Application Number: 19/02141/FUL

Description New residential dwelling (retrospective) and associated works

At Site To The West of 1, London End Lane, Bow Brickhill,

Report Author/Case Officer: Jeremy Lee
Senior Planning Officer

SITE LANDSCAPING PLAN 1:200 @ A1

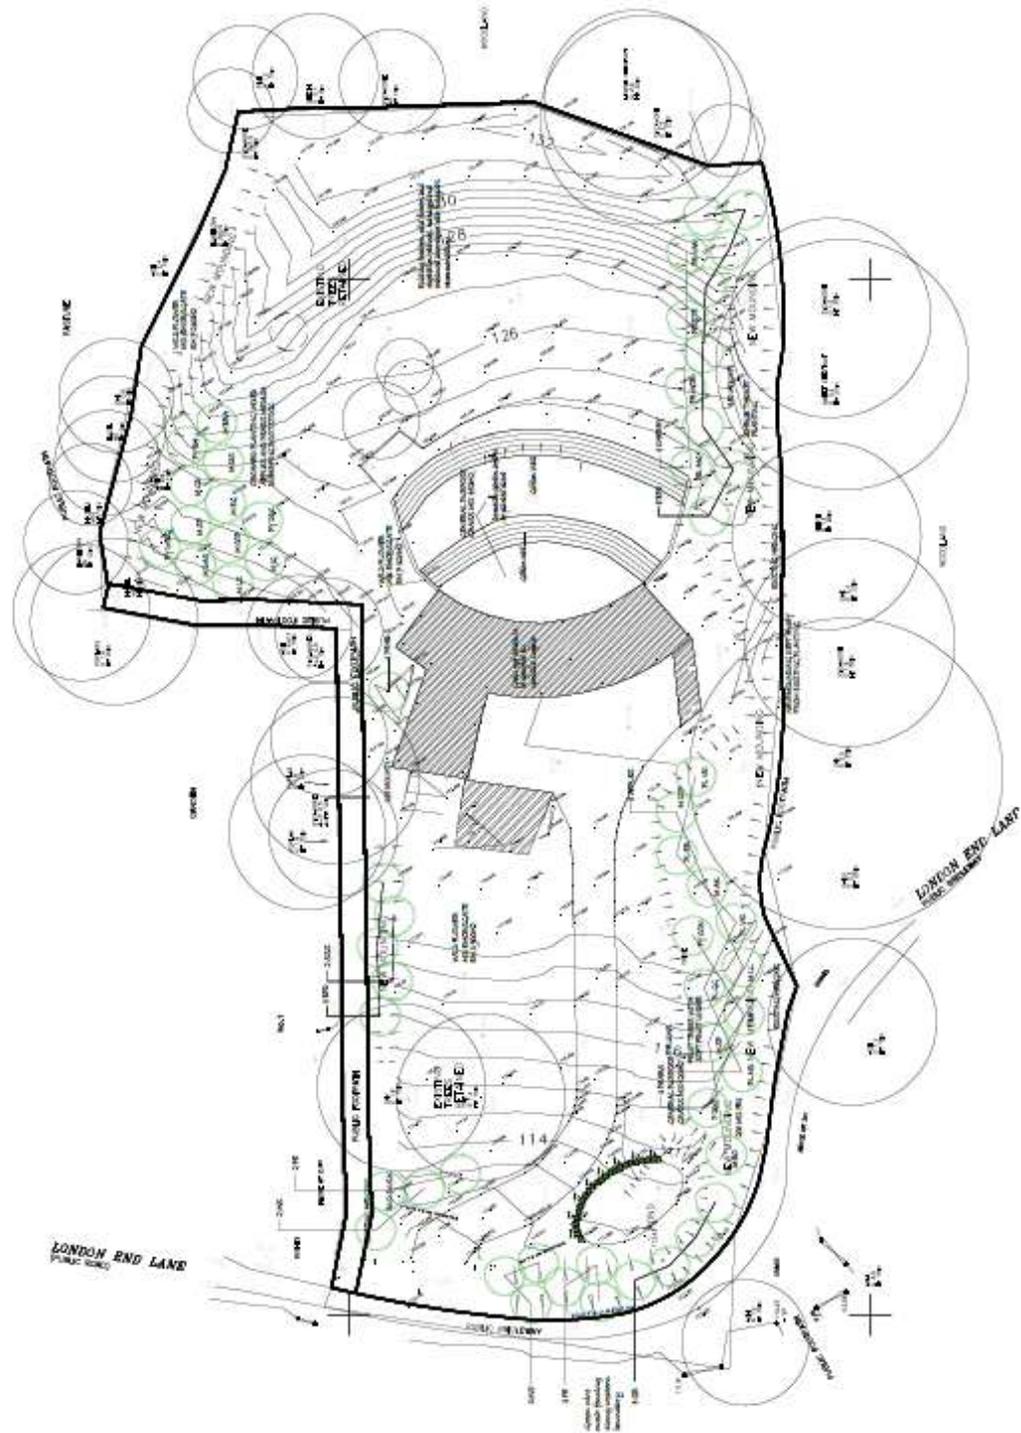
The applicant has submitted a Site Landscape Plan, which shows a range of features that could be considered to be ecological enhancements. This includes:

- The planting of a range of tree species;
- The use of wildflower mixes to create meadows to the front and rear of the house;
- The retention of trees to the front and rear of the house;
- The creation of a pond on site.

A site visit in October 2019 highlighted that these features/management measures are either missing or have not been implemented in an appropriate way. The majority of the site is now covered by homogeneous rough grassland and has not been managed with biodiversity in mind. No trees have been planted on site and of the retained trees, two are dead and the rest have significant damage from construction activities and pruning (further advice should be sought from the MKC Arboriculture Officer and/or Landscape Technical Officer).

Floor Plan 1:100

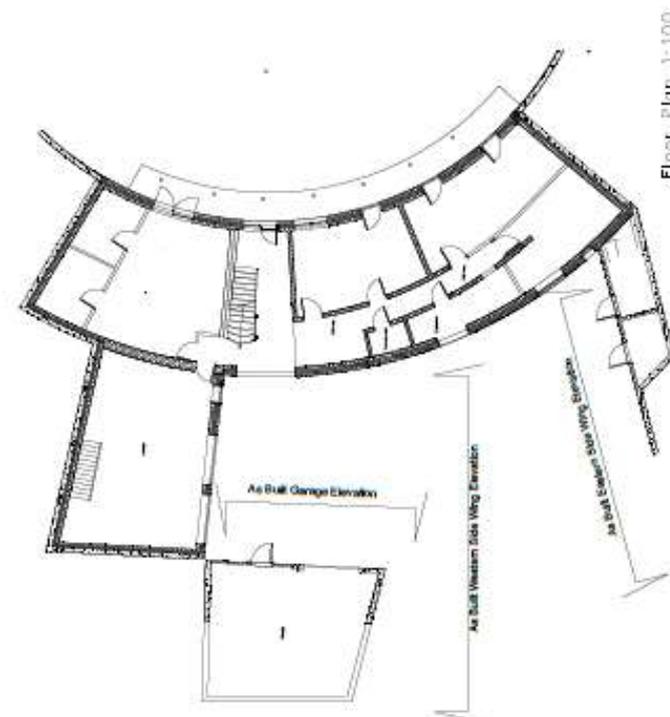
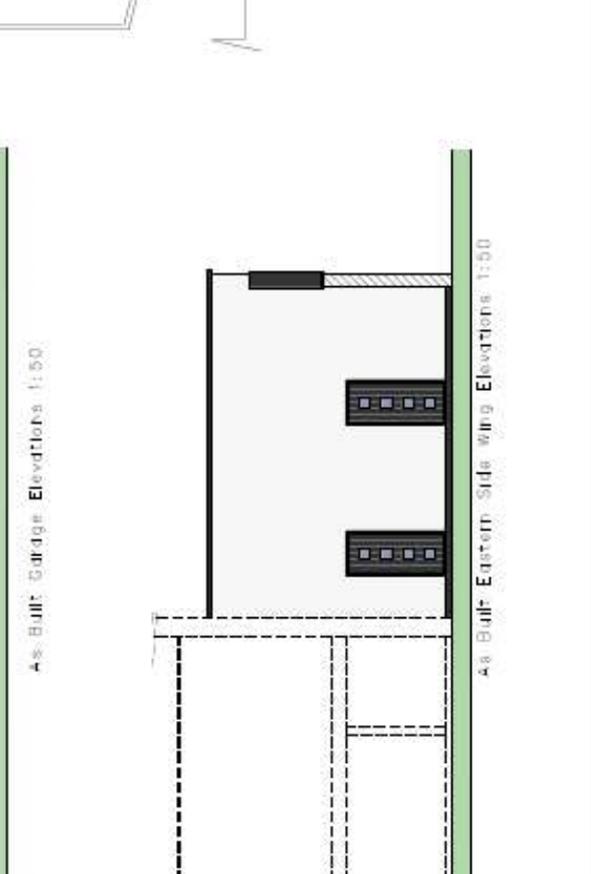
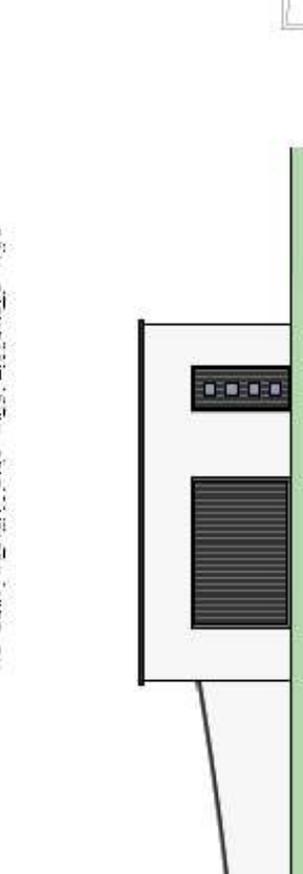
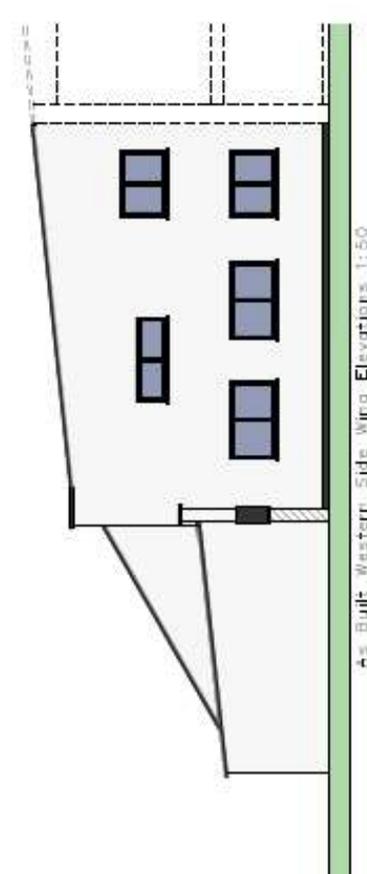
The submitted drawings do not include the required turning area that was shown on the approved plans.

I would recommend that original features of the façade, particularly those that soften the elevation, such as the timber cladding be reinstated. The proposed landscaping to the front of the dwelling should be reinstated to minimise the visual impact of the building and help the building integrate with its natural setting. The garage as built would ideally be removed or hidden with extensive landscaping placed in front of the garage.

- Removing the garage as it hasn't got planning permission and is a prominent blank façade facing the public right of way
- Alterations to the white façade that highlights the building within its setting as opposed to a more sympathetic facade. I'd encourage the use of the approved timber cladding system as this will weather and integrated with the natural environment
- The approved landscape scheme including the approved ground levels needs to be delivered to minimise the impact of the dwelling on the natural setting.

The plans also need to reflect what has / or is being built on site.
